Addendum No. 01

Subject: Edward T. Steel Elementary School – Emergency Generator Replacement
SDP Contract No. B-057 (C) of 2016/17

Location: Edward T. Steel Elementary School
4301 Wayne Ave.
Philadelphia, Pennsylvania 19140

ELECTRICAL DUCT BANK INSTALLATION UNDER CONCRETE OR ASPHALT DETAIL 9
NOT TO SCALE

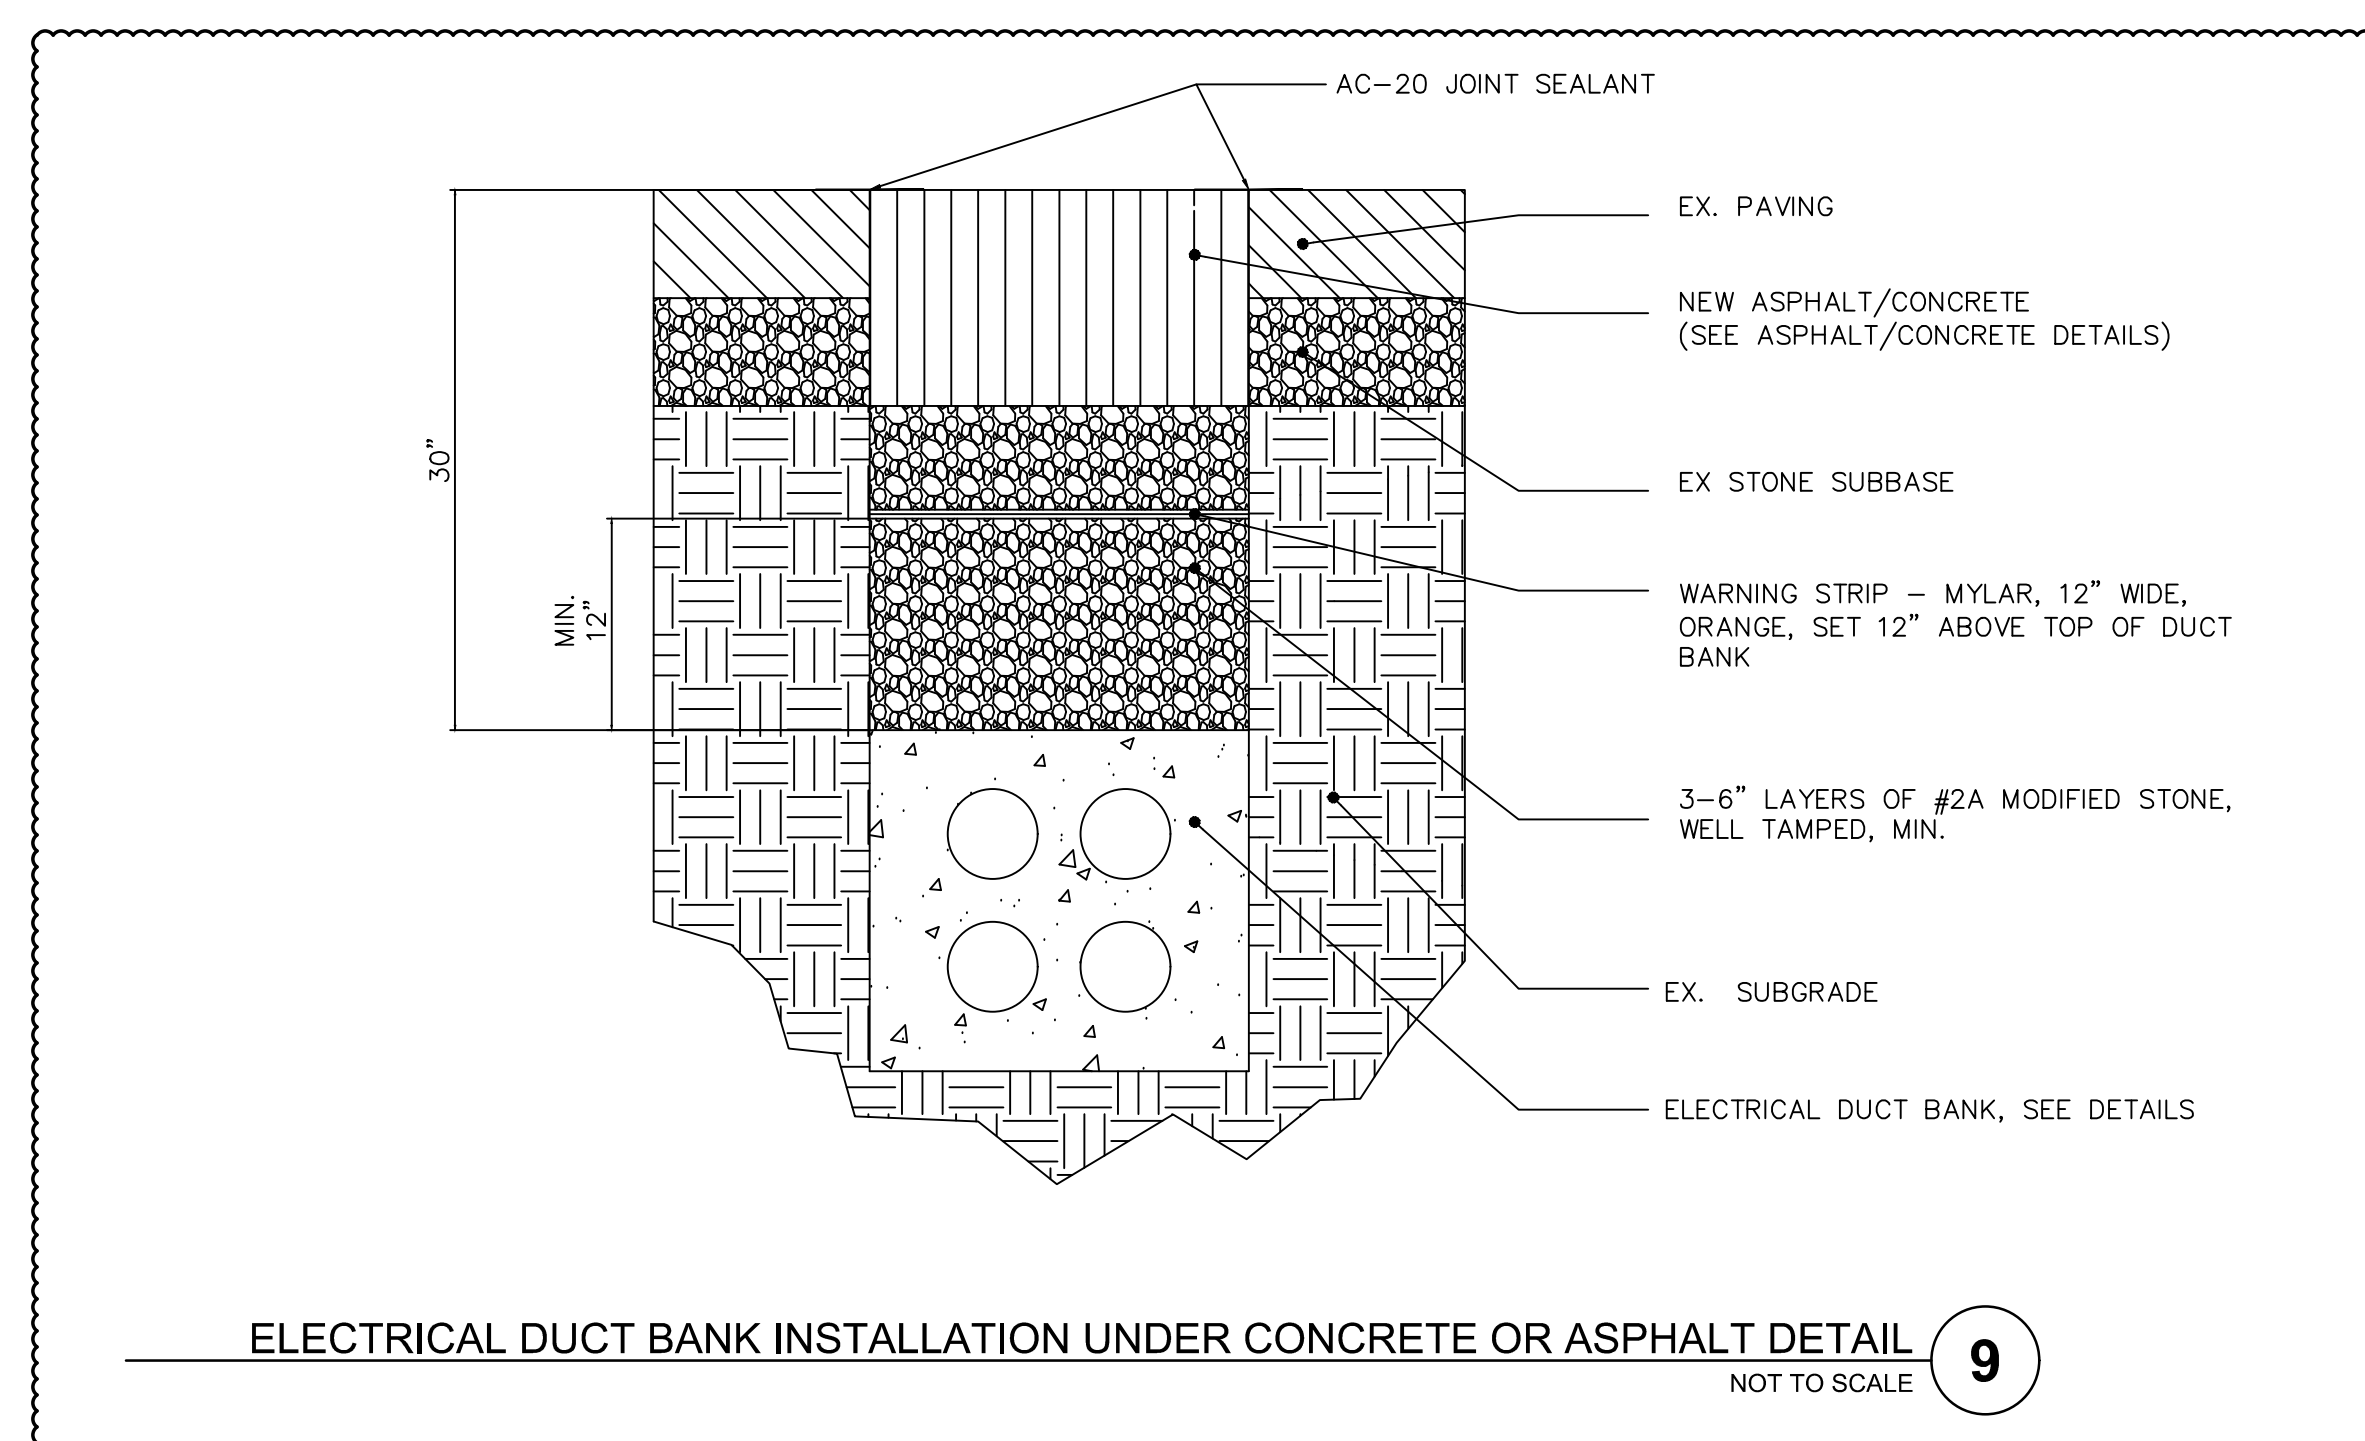
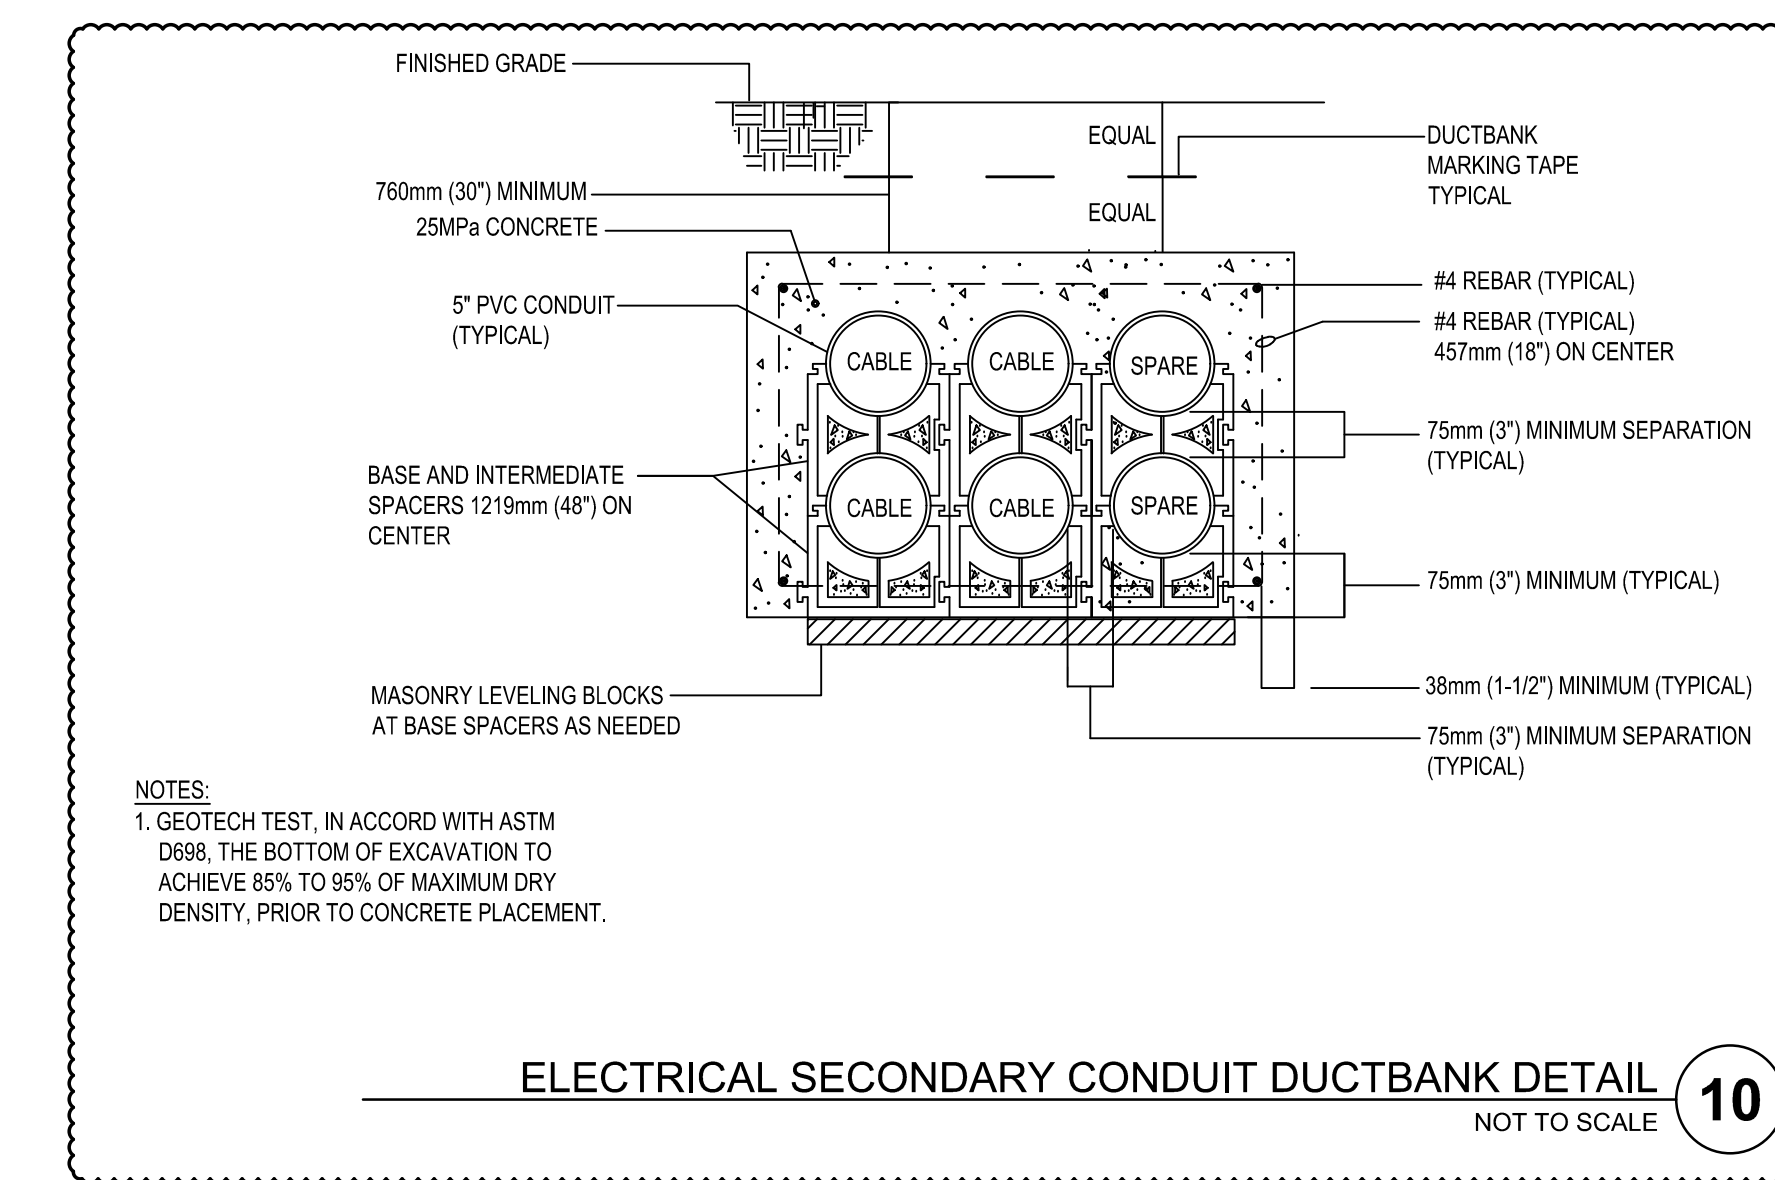
E501 – Added bollard and conduit routing details.
